HISTORIC AND DESIGN REVIEW COMMISSION

HDRC CASE NO: 2022-345
ADDRESS: 305 LAVACA ST
LEGAL DESCRIPTION: NCB 708 BLK 8 LOT 2
ZONING: RM-4, H
CITY COUNCIL DIST.: 1
DISTRICT: Lavaca Historic District
APPLICANT: Caroline Gado
OWNER: Leslie Jones/1918 MLK DEVELOPMENT GROUP LLC
TYPE OF WORK: New construction of two, 2-story duplex structures
APPLICATION RECEIVED: June 13, 2022
60-DAY REVIEW: Not applicable due to City Council Emergency Orders
CASE MANAGER: Rachel Rettaliata

The applicant is requesting conceptual approval to construct two, 2-story duplex structures at 305 Lavaca.

Historic and Design Review Commission
Design Review Committee Report

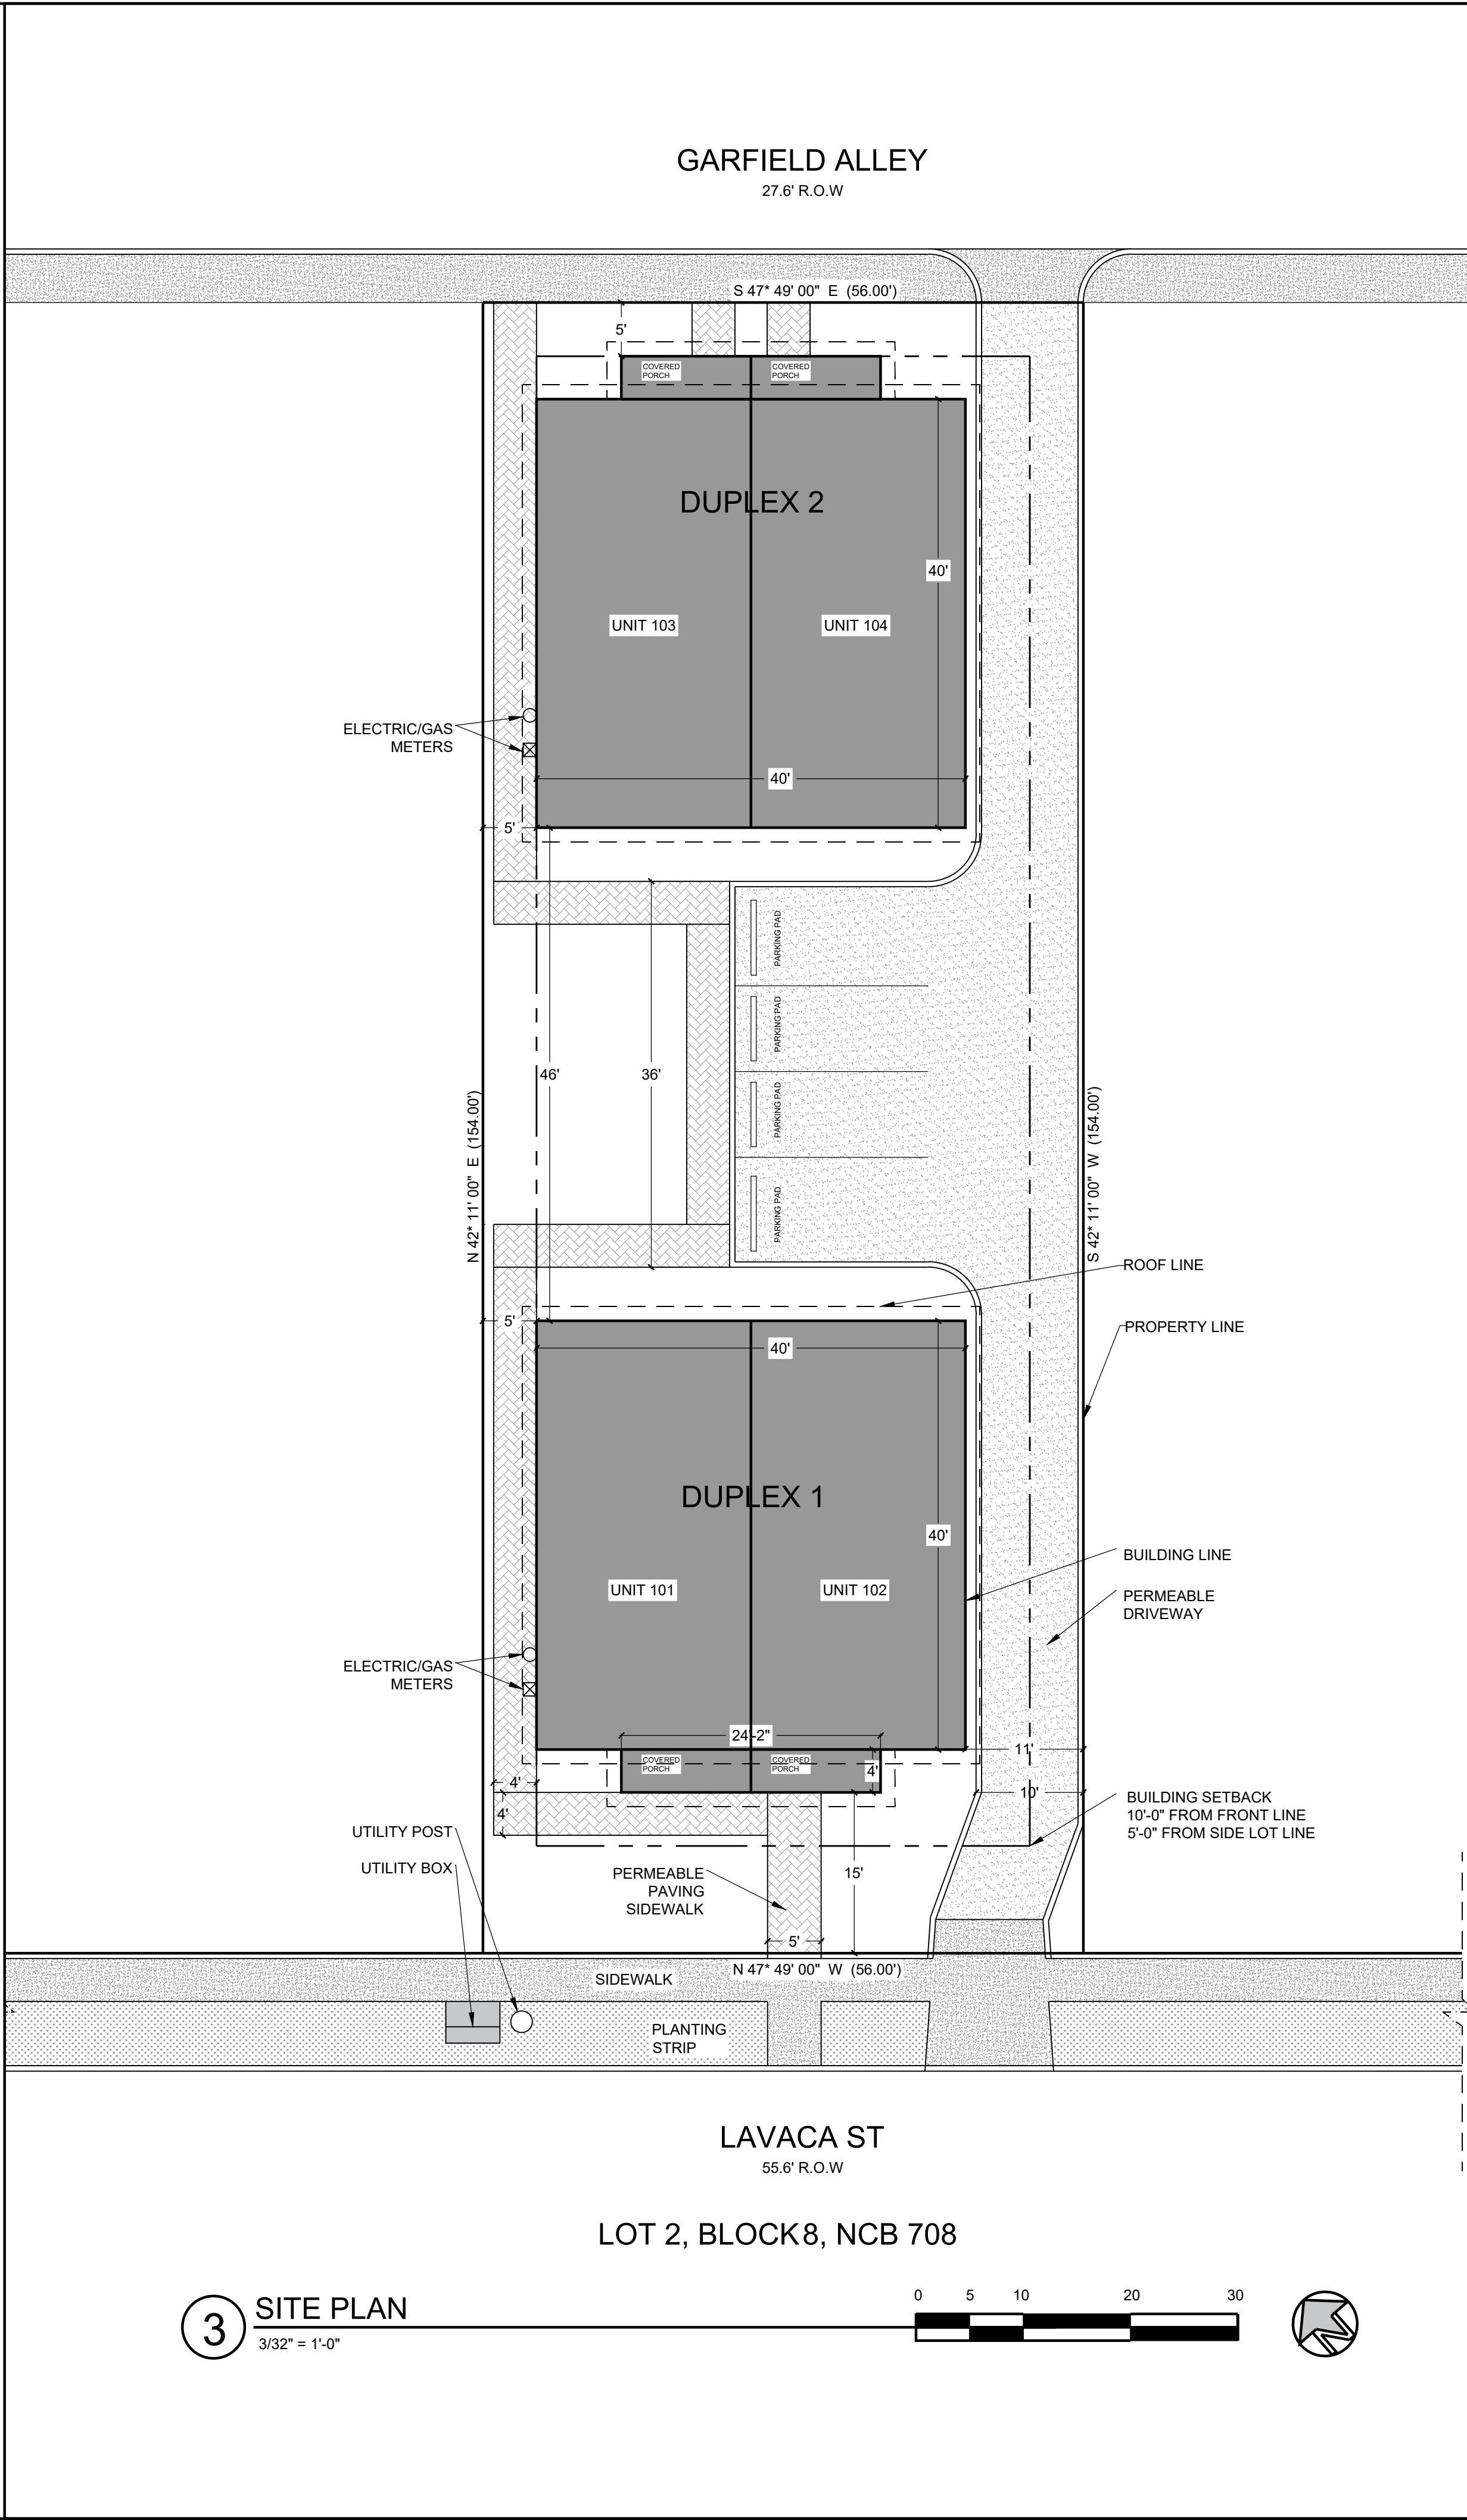
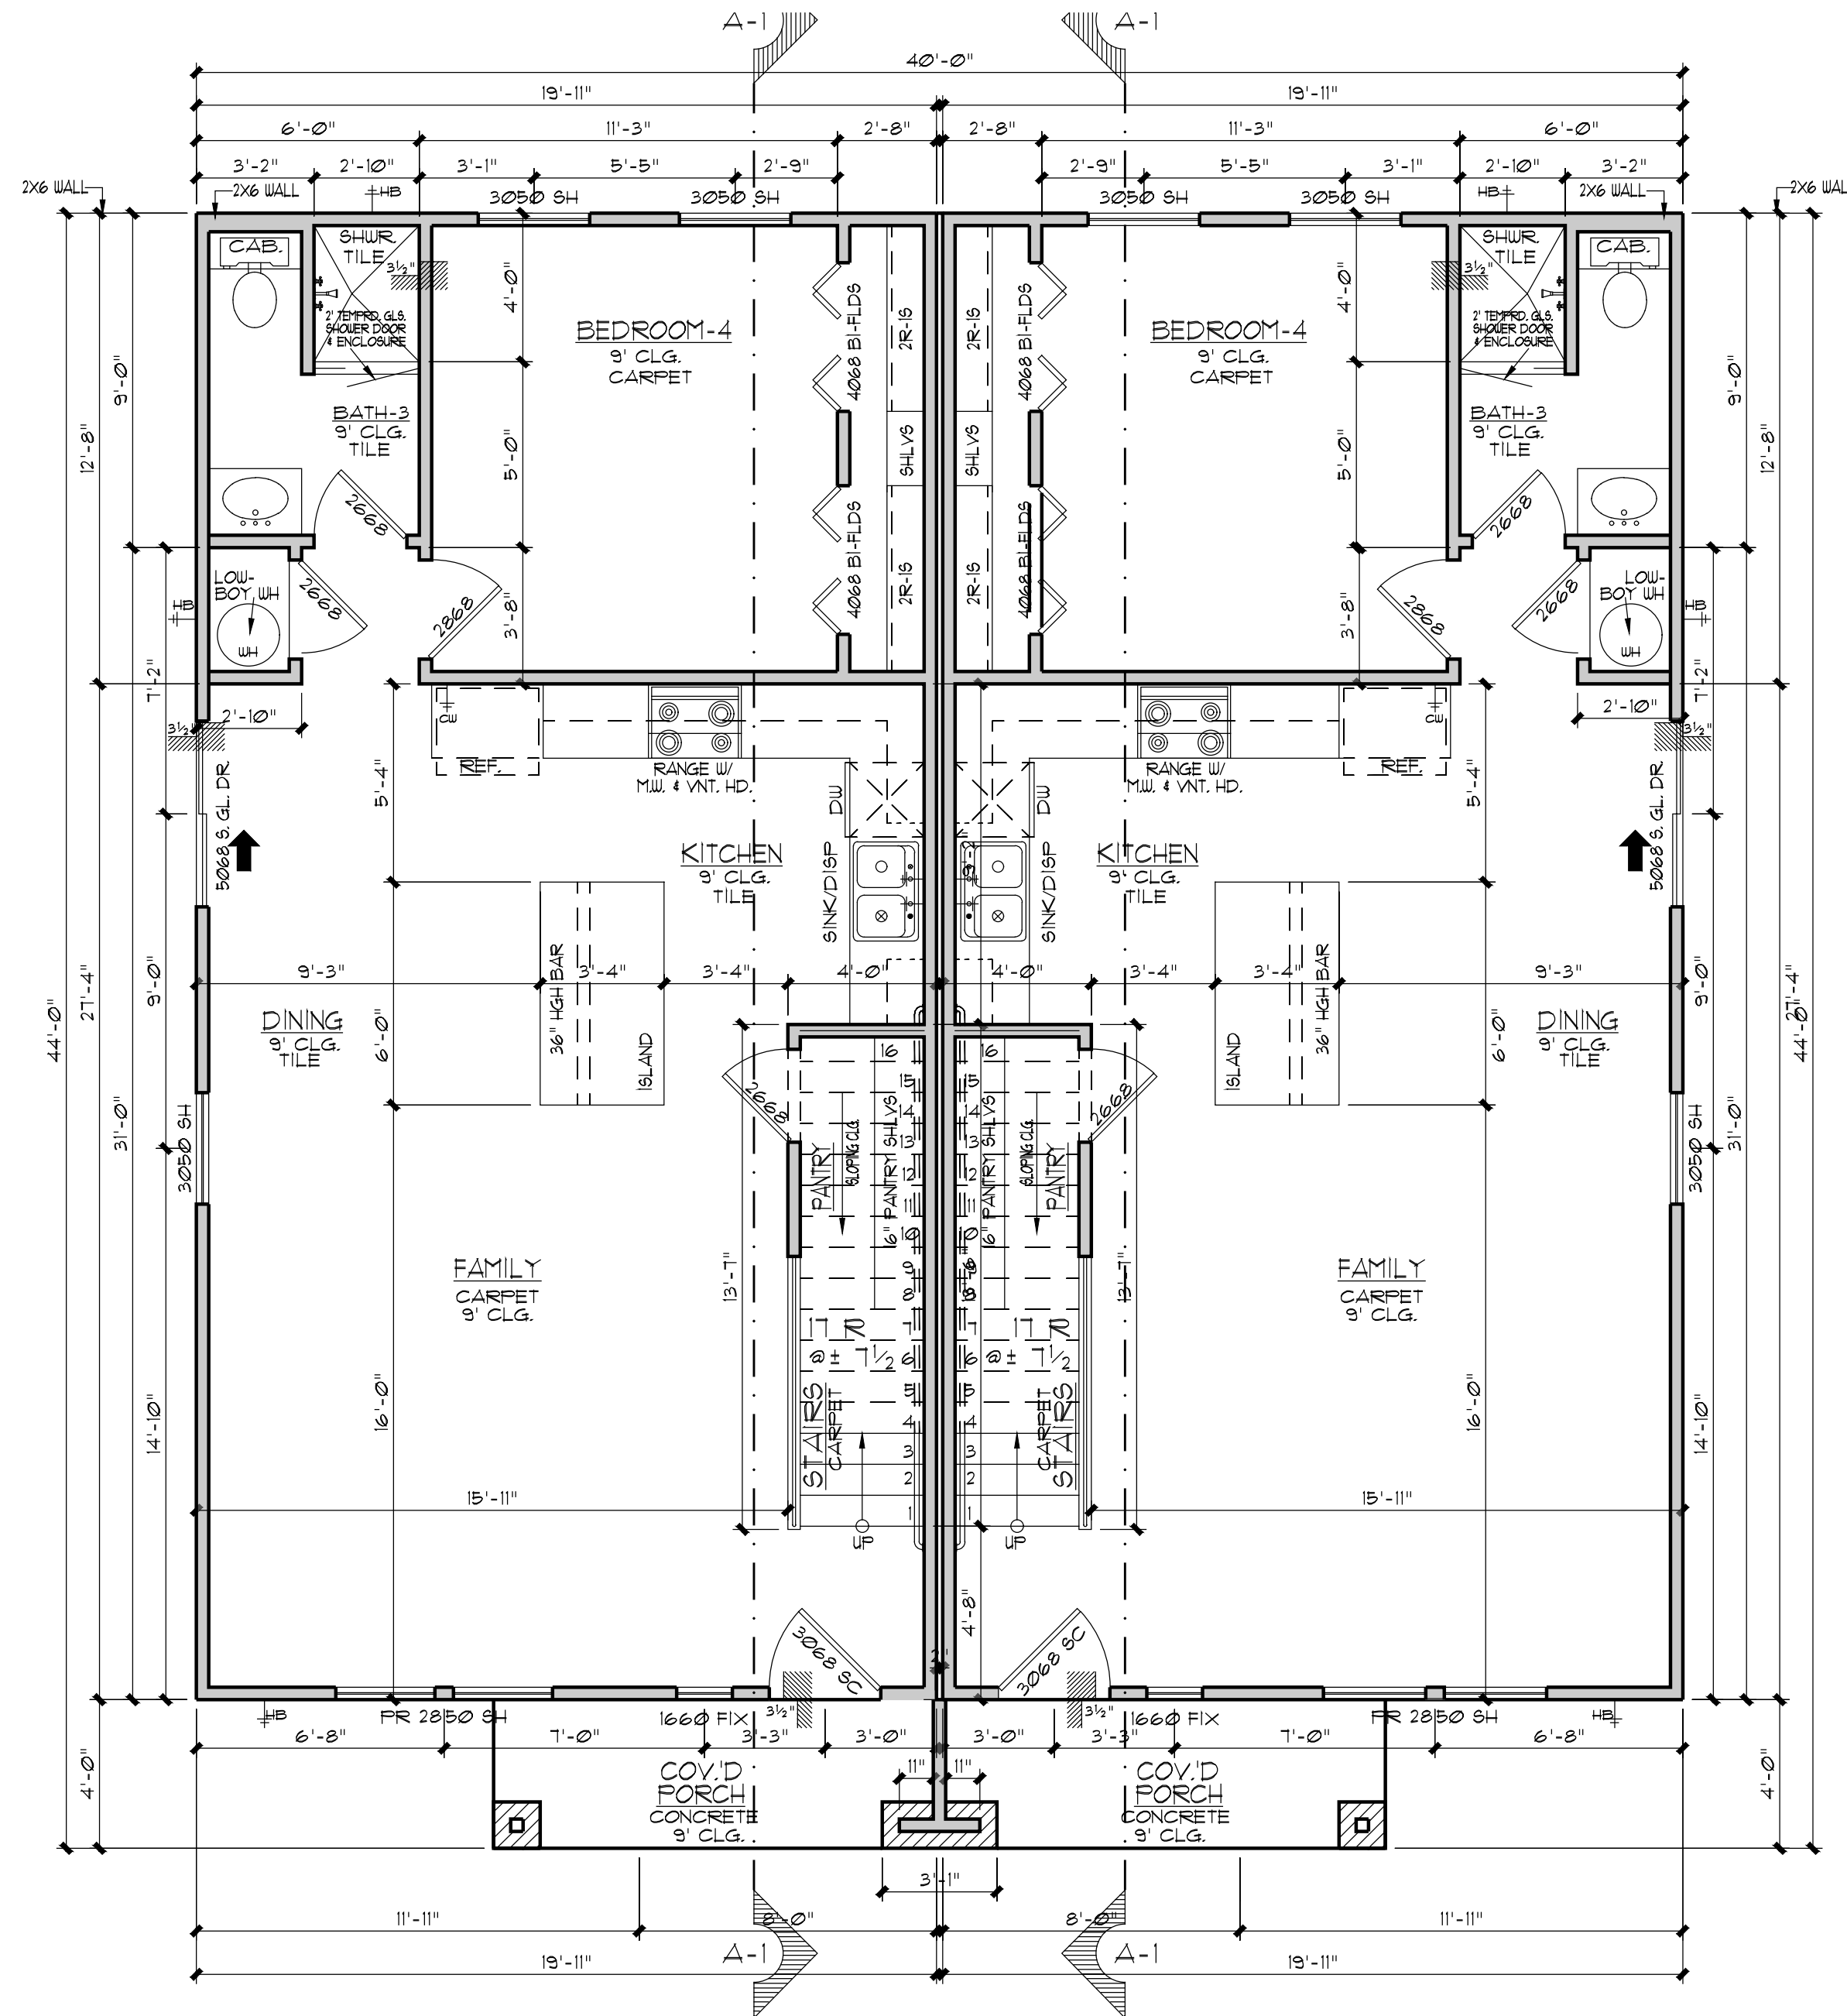
- j. **LOT COVERAGE** – Guideline 2.D.i for New Construction stipulates that building to lot ratio for new construction should be consistent with adjacent historic buildings. Limit the building footprint for new construction to no more than 50 percent of the total lot area, unless adjacent historic buildings establish a precedent with a greater building to lot ratio. The applicant has expressed that each duplex will total 1,696 square feet and the proposed lot coverage will be 39.4 percent. Staff finds the proposal appropriate.

permeable driveway on the east property line, extending the full length of the property from Lavaca to Garfield Alley with a central parking pad with four (4) parking spaces. Staff finds the proposal generally appropriate and finds that the applicant should submit material specifications for the permeable surfacing to staff for review and approval.

- v. That the applicant incorporates front porch elements that are in keeping with the historic structures on the block based on finding o.
- vi. That the applicant submits material specifications for the permeable surfacing to staff for review and approval prior to returning to the HDRC for final approval based on finding p.
